Index 102-615 Multilane, Work in Intersection

COMMENTARY

COMMENTS AND RESPONSES

LAST REVISION 11/01/20	REVISION	DESCRIPTION:	 FY 2021-22 STANDARD PLANS	MULTILANE ROADWAY, INTERSECTION WORK	INDEX 102-615	SHEET 4 of 5
---------------------------	----------	--------------	--	--------------------------------------	------------------	-----------------

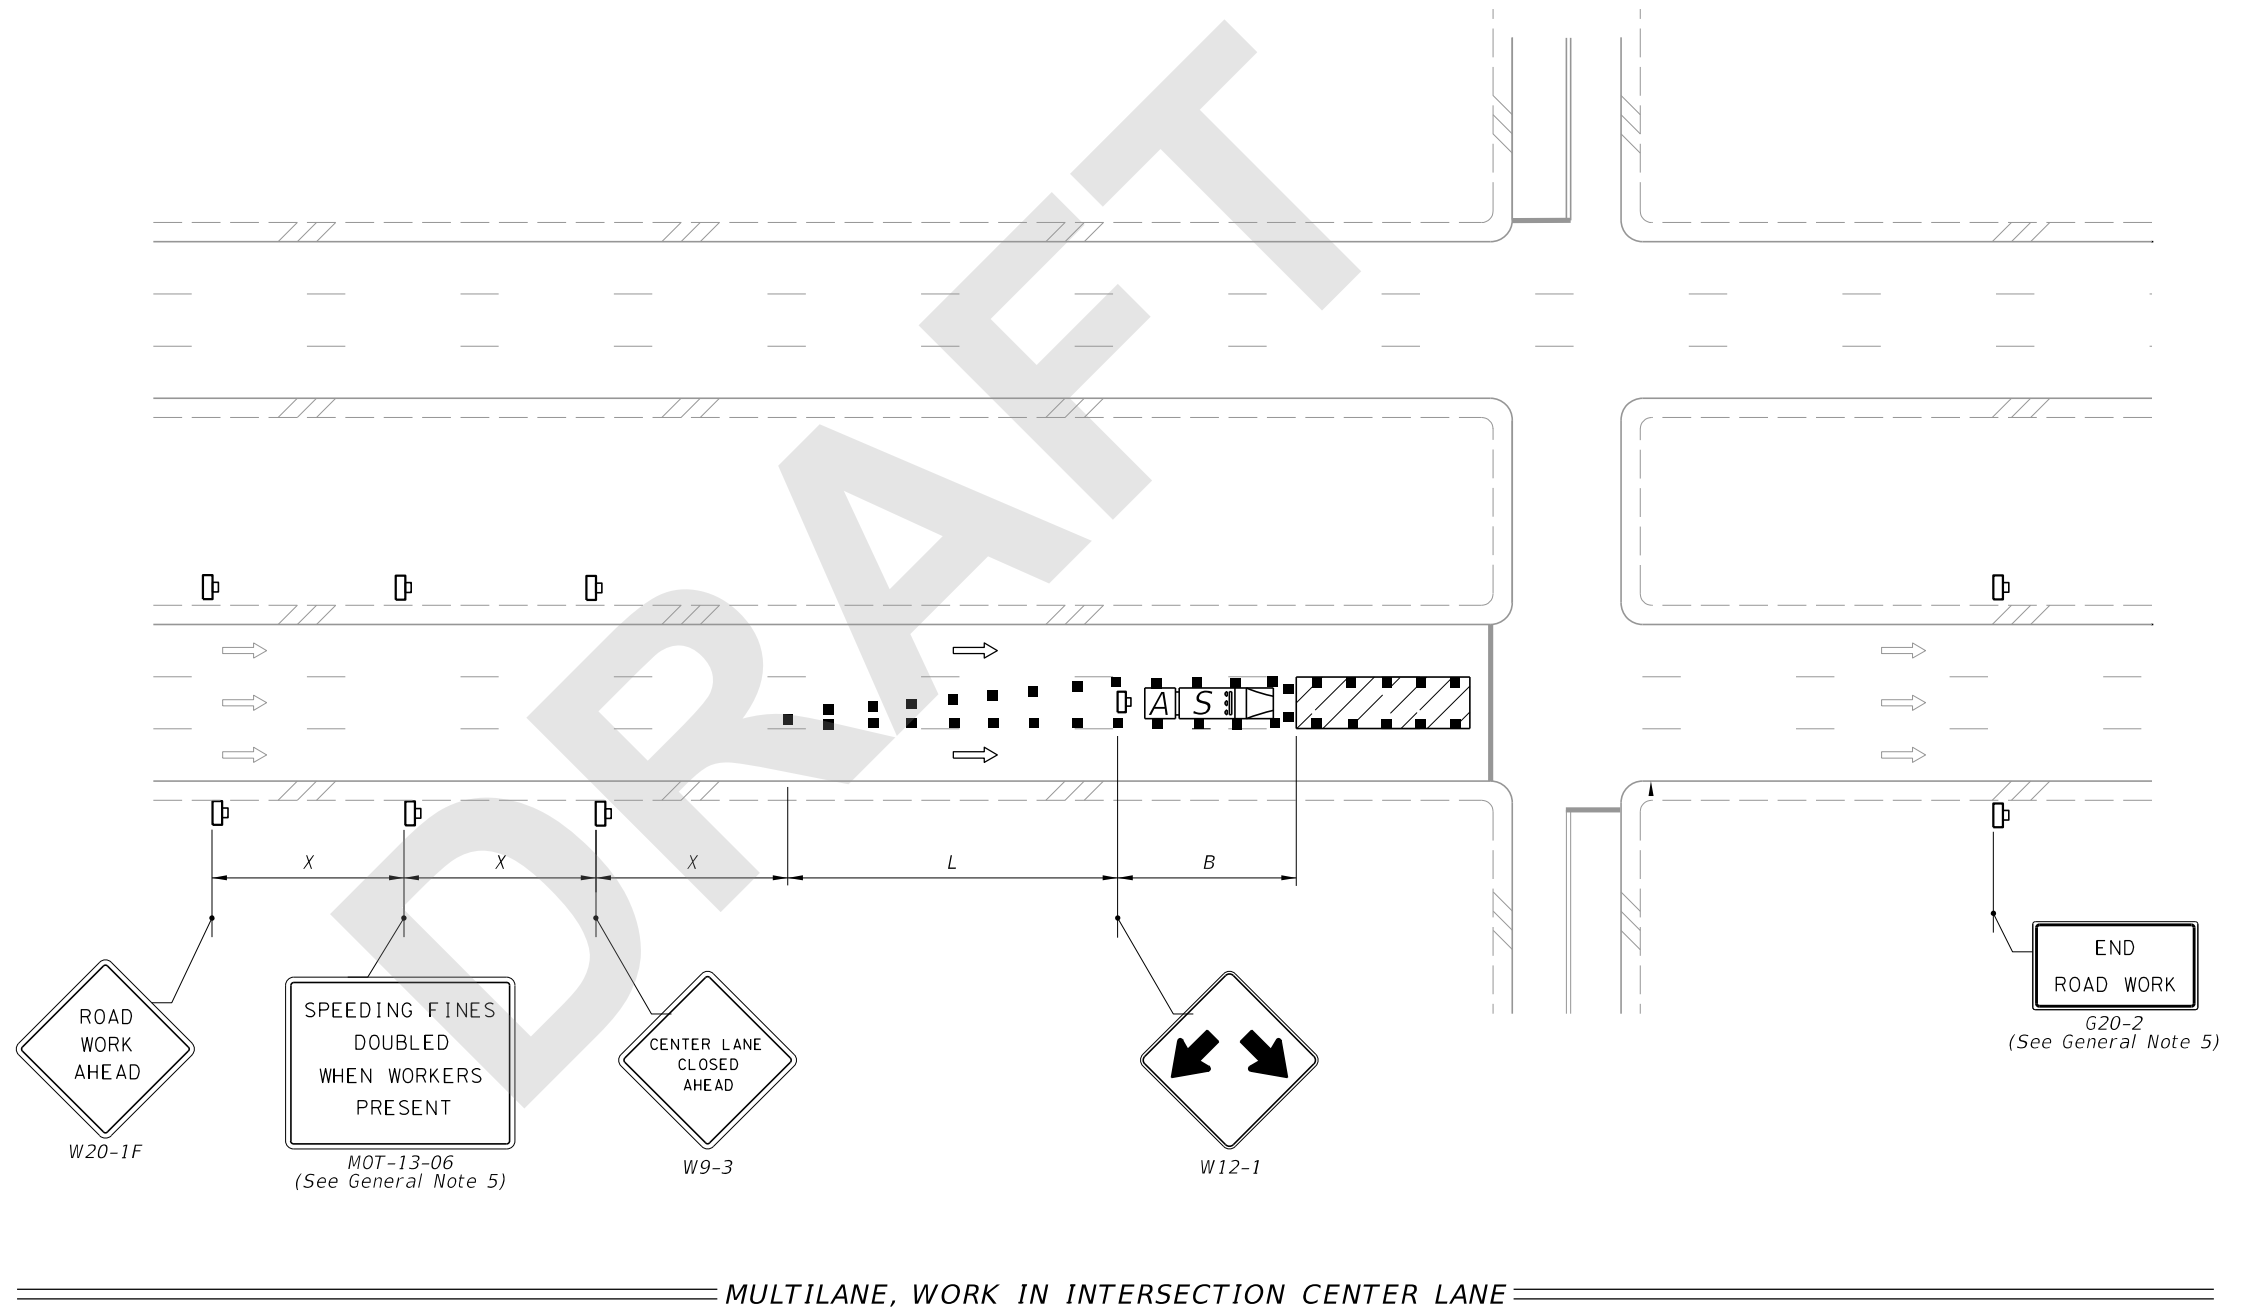
Sheet 4: Added Index 102-617 as Sheet 4; Revised Detail and Notes; Deleted 'Distance Between Signs', 'Table I Device Spacing', and 'Table II Taper Length -Merge' Tables (Moved to 102-600); Deleted Duration Notes and Conditions; Changed Index Title.

LAST REVISION 11/01/20	REVISION	DESCRIPTION:		FY 2021-22 STANDARD PLANS	MULTILANE ROADWAY, INTERSECTION WORK	INDEX 102-615	SHEET 5 of 5
---------------------------	----------	--------------	--	------------------------------	--------------------------------------	------------------	-----------------

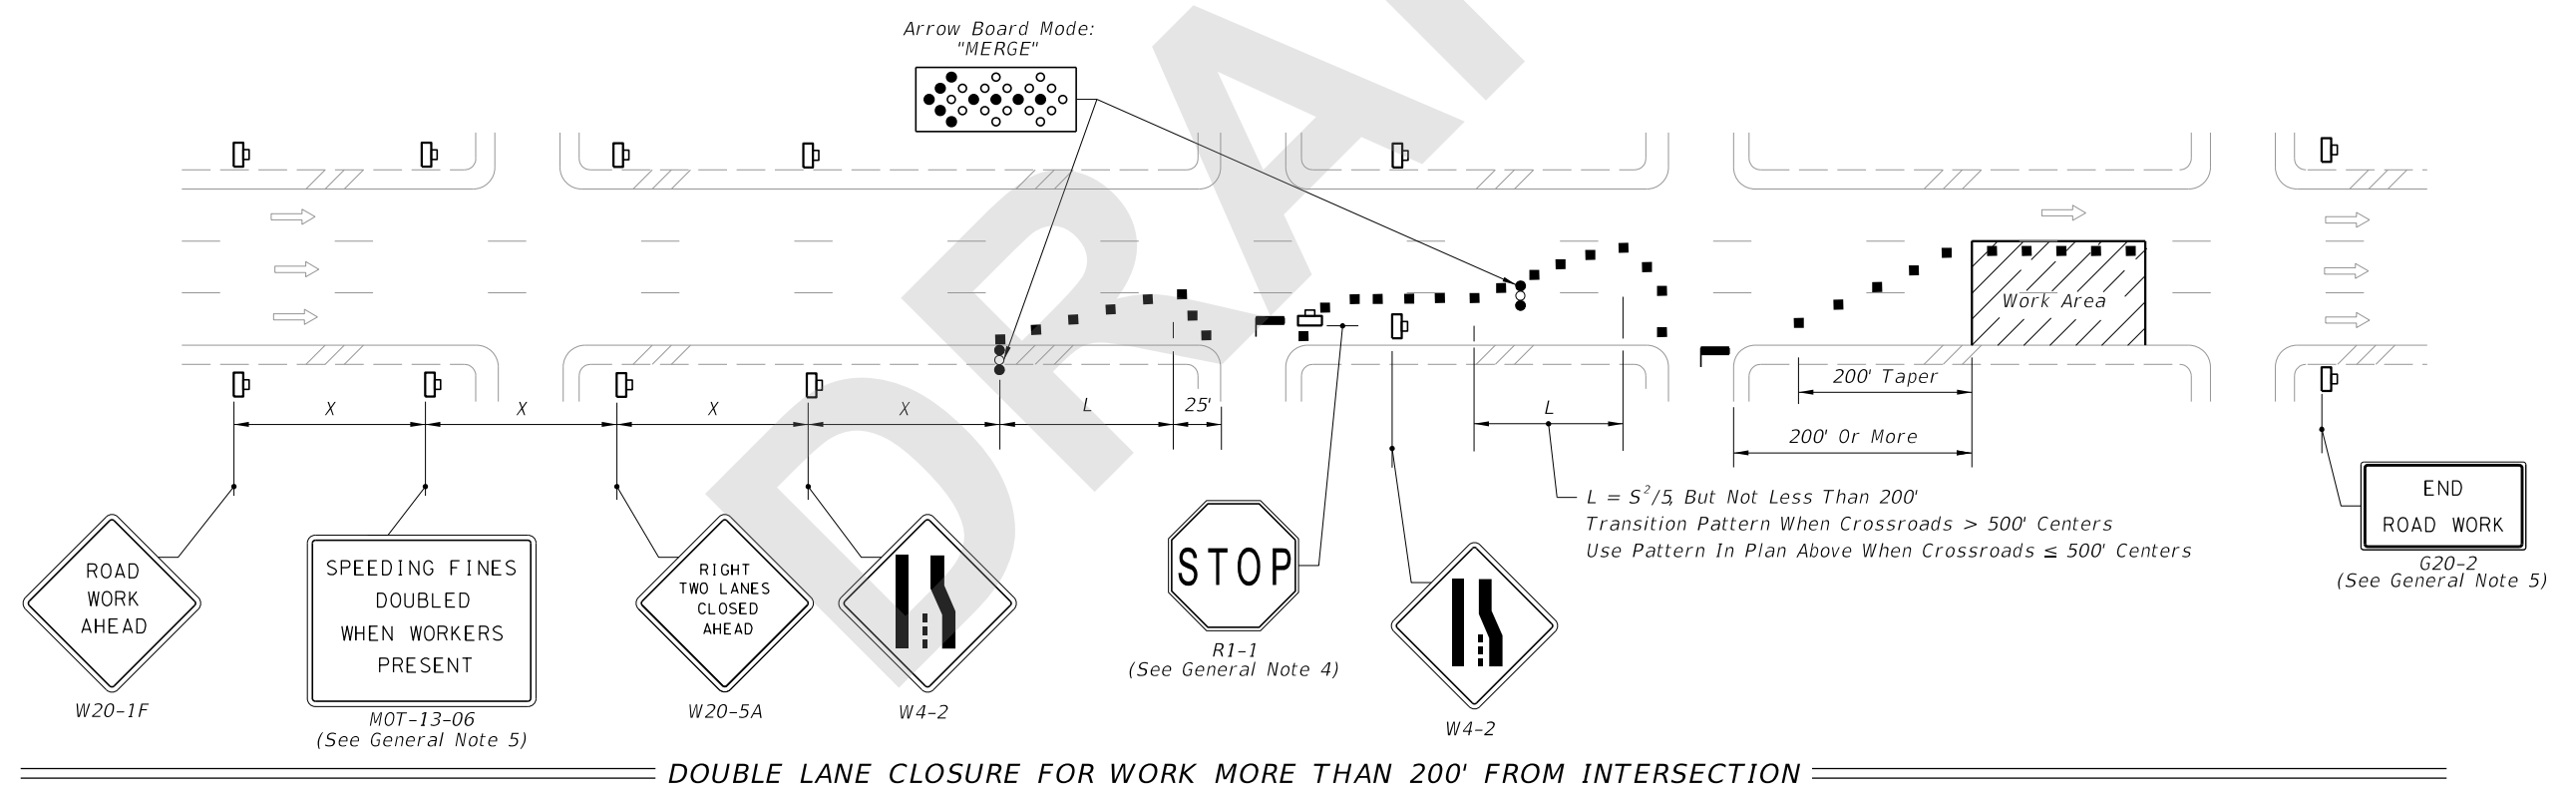
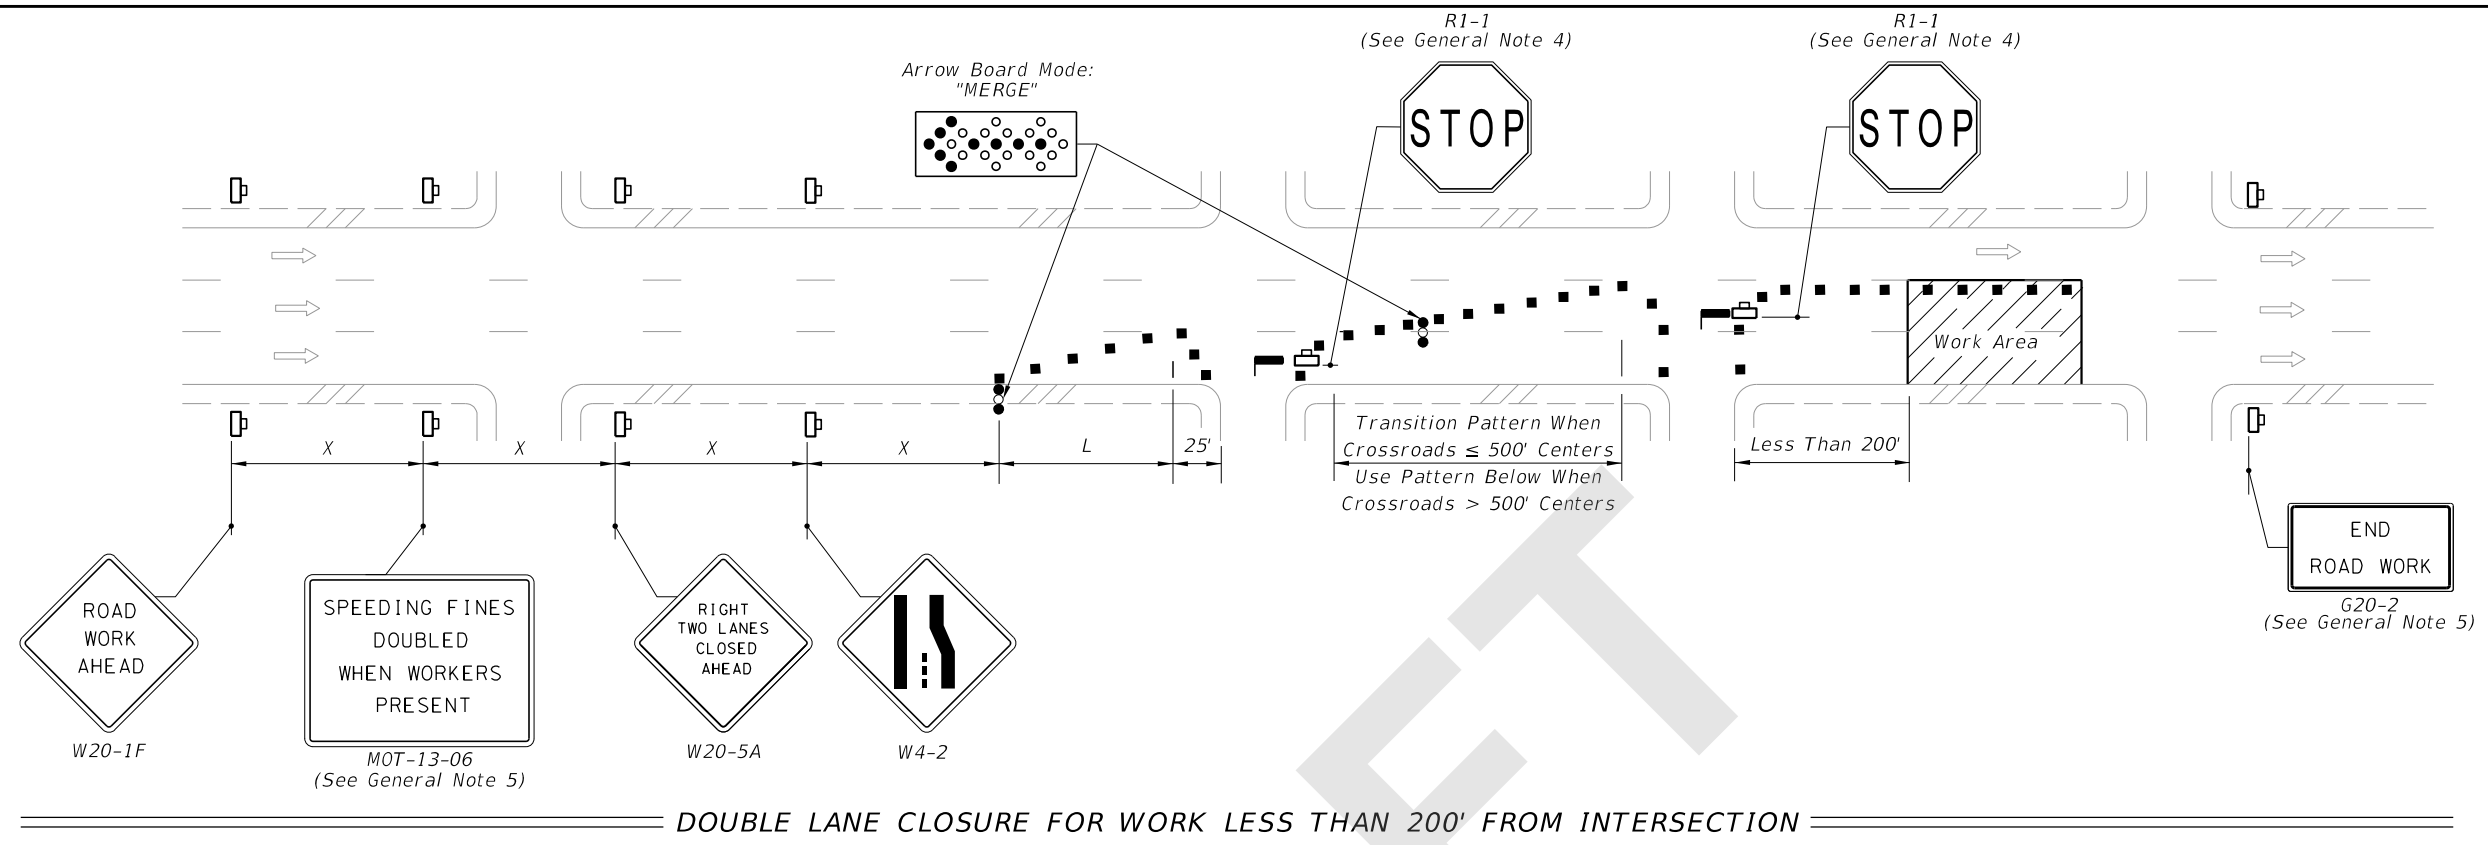
Sheet 5: Added Index 102-618 as Sheet 5; Revised Details and Notes; Deleted 'Table II Taper Length – Merge' Table (Moved to 102-600) and Conditions; Changed Index Title.

2. Sheet 5 of 5: “DOUBLE LANE CLOSURE FOR WORK MORE THAN 200’ FROM INTERSECTION”

POSSIBLE PROBLEM: Design has 200 ft or more from intersection to work area and shows a 200-ft taper within that 200 ft or more area. That could allow for the taper to begin immediately at the intersection which effectively creates an “acceleration” taper setup. A driver might be induced to turn and “race” to merge into the one lane of traffic.

RECOMMENDED CHANGE: Call for the 200’ or more to be between the intersection and the BEGINNING of the 200’ Taper.

RESPONSE: Comment acknowledged; however, application has been used for many years with no known issues. We will continue to monitor for possible future improvements.
